Duane Arnold Energy Center
Docket No. 50-331
Renewed Op. License No. DPR-49

Response to Request for Additional Information, License Amendment Request to Adopt National Fire Protection Association Standard 805, Performance-Based Standard For Fire Protection For Light Water Reactor Generating Plants

Response to Request for Additional Information, License Amendment Request to
Adopt National Fire Protection Association Standard 805, Performance-Based
Standard For Fire Protection For Light Water Reactor Generating Plants

DETAIL "A"
DOOR 223

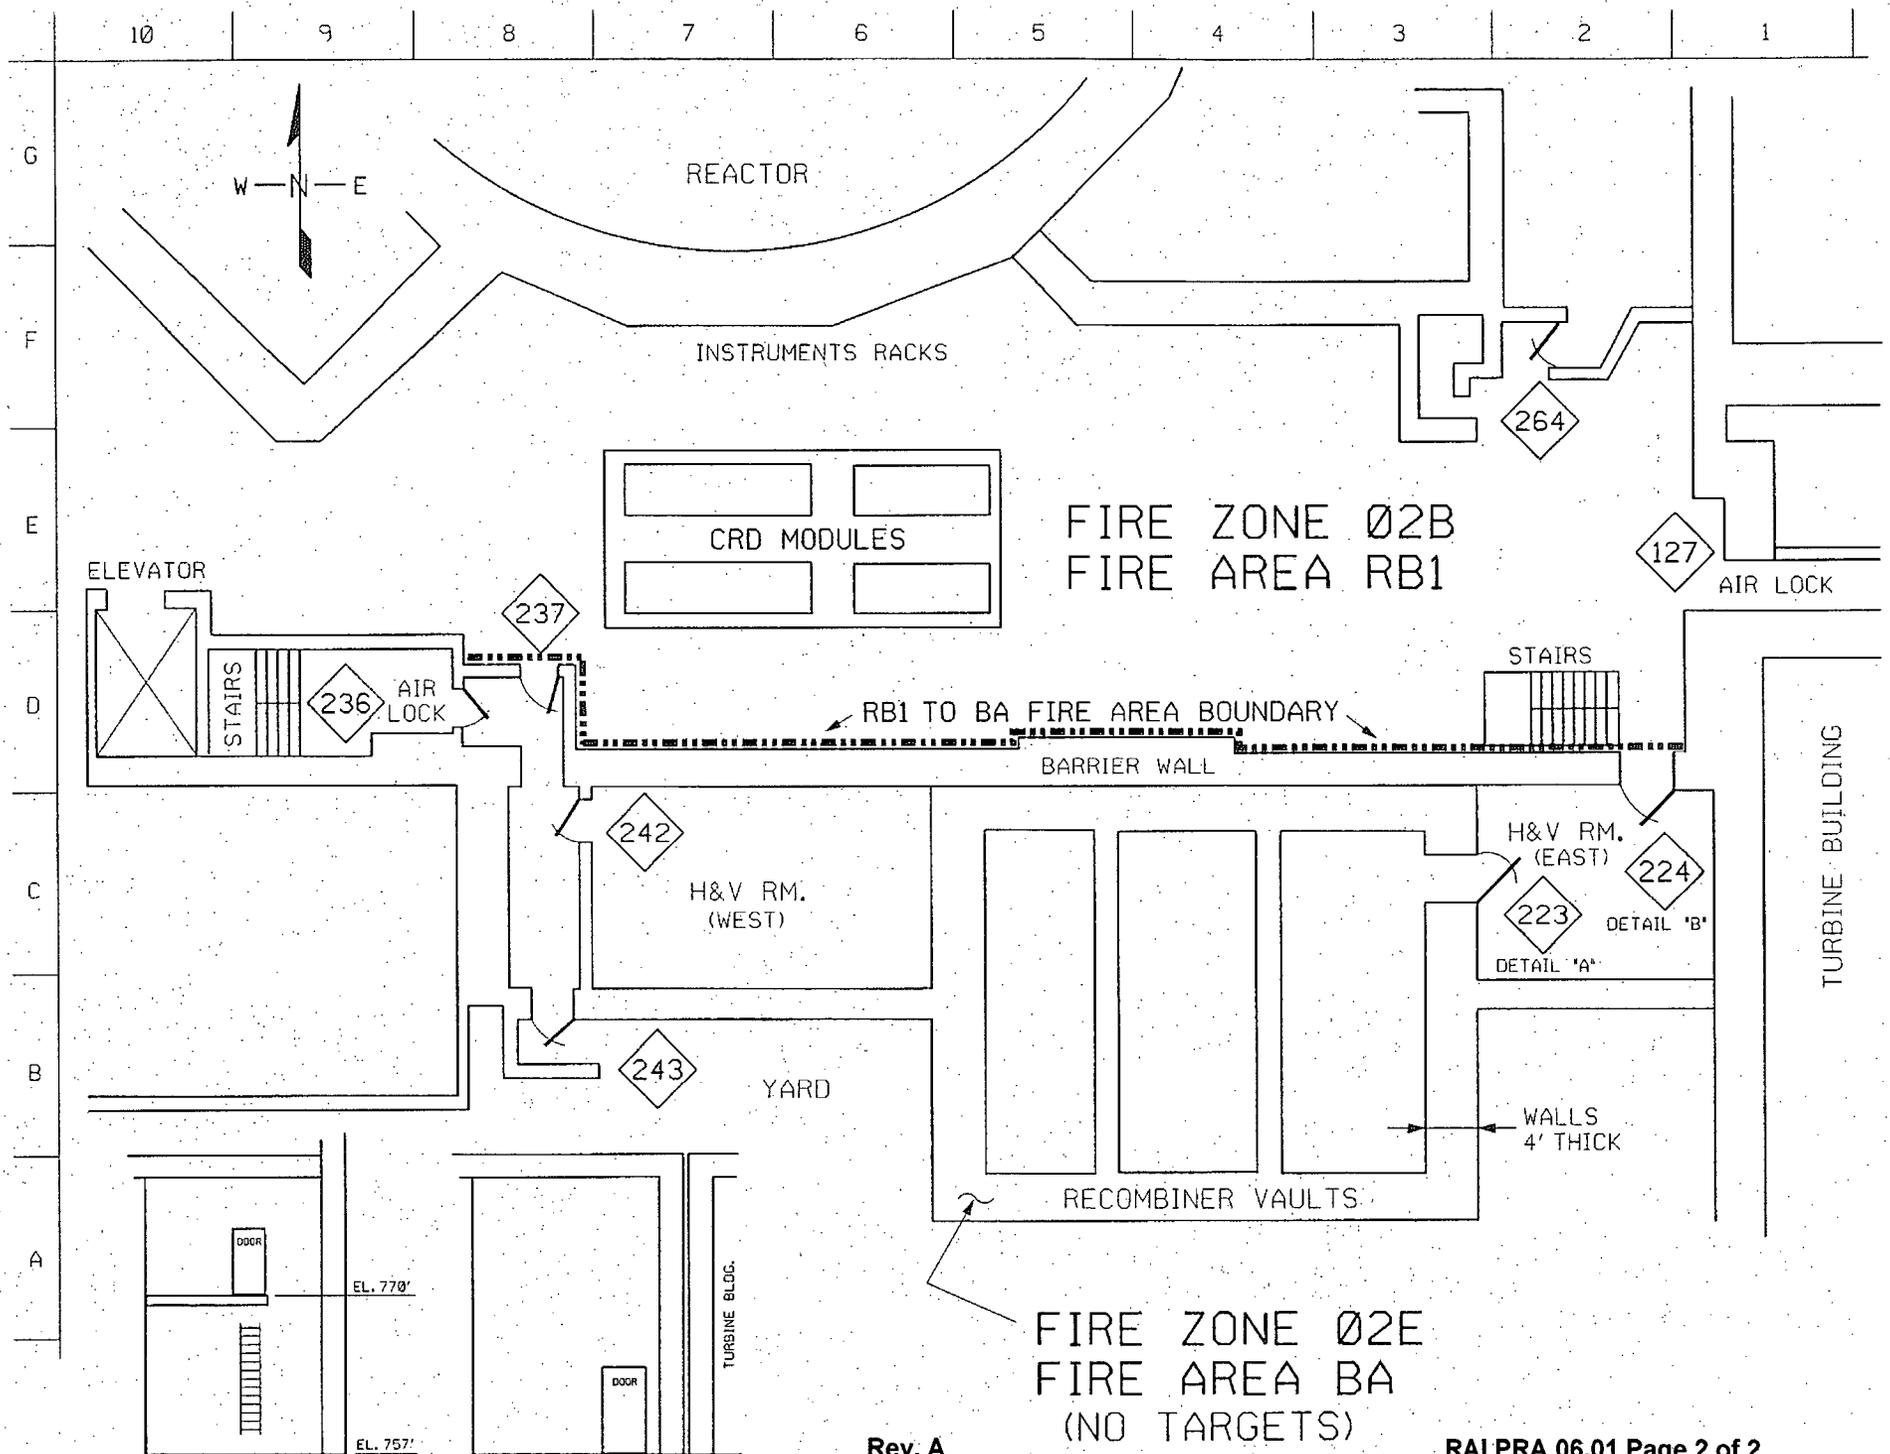
In your letter dated May 23, 2012 (ADAMS Accession No. ML12146A094) you responded to PRA RAI 06. PRA RAI 06 discussed the multi-compartment analysis (MCA) from 02E to 02B, and your response stated the following:

"When considering a hydrogen recombiner fire event, the fire is most likely to propagate to 02B through the east recombiner vault door and heating, ventilation, and air conditioning (HVAC) room door. The target set outside the HVAC room door in 02B does not contain FPRA cables."

- a. The response did not address potential impact of fire propagation through the east recombiner door. Discuss the analysis of this potential pathway for this scenario.
- b. In addition, since the fire area is a control rod drive (CRD) module area, discuss whether a potential impact on the CRD modules exists and was considered in the risk analysis. Describe the impact on the results of this MCA analysis.

- a. FHA-400 provides discussion of the construction of PAU 02E. PAU 02E is the Offgas Recombiner Room. The offgas condenser and recombiners are contained in a concrete vault and there are HVAC equipment rooms on the east and west sides of the vault. Access to the vault is via door 223 (location C2 on attached sketch) between the vault and east HVAC room. A door in each HVAC room opens into PAU 02B. The north wall of PAU 02E is continuous with PAU 02B.

There are two multi compartment interactions considered for a hydrogen recombiner fire between PAUs 02E and 02B that involve doors.

1. A hydrogen recombiner fire that is postulated to propagate into the east HVAC room via the failure of vault door 223 and subsequently into PAU 02B via failure of the east HVAC room door 224 (location C1 on attached sketch). There are no fire PRA targets outside the east HVAC room door.

2. A hydrogen recombiner fire that is postulated to propagate into the west HVAC room via failure of the four foot thick vault wall and subsequently into PAU 02B via failure of the west HVAC room door 242 (location C7 on attached sketch) and the emergency airlock egress door 237 (location D8 on attached sketch). There are no fire PRA targets outside the west HVAC room door.

- b. In the MCA for PAUs 02E and 02B, impacts to the CRD modules were not postulated. A fire propagation pathway does not exist from the doors to the CRD modules. Additionally, HGL concern does not exist because of the large volume of PAU 02B.
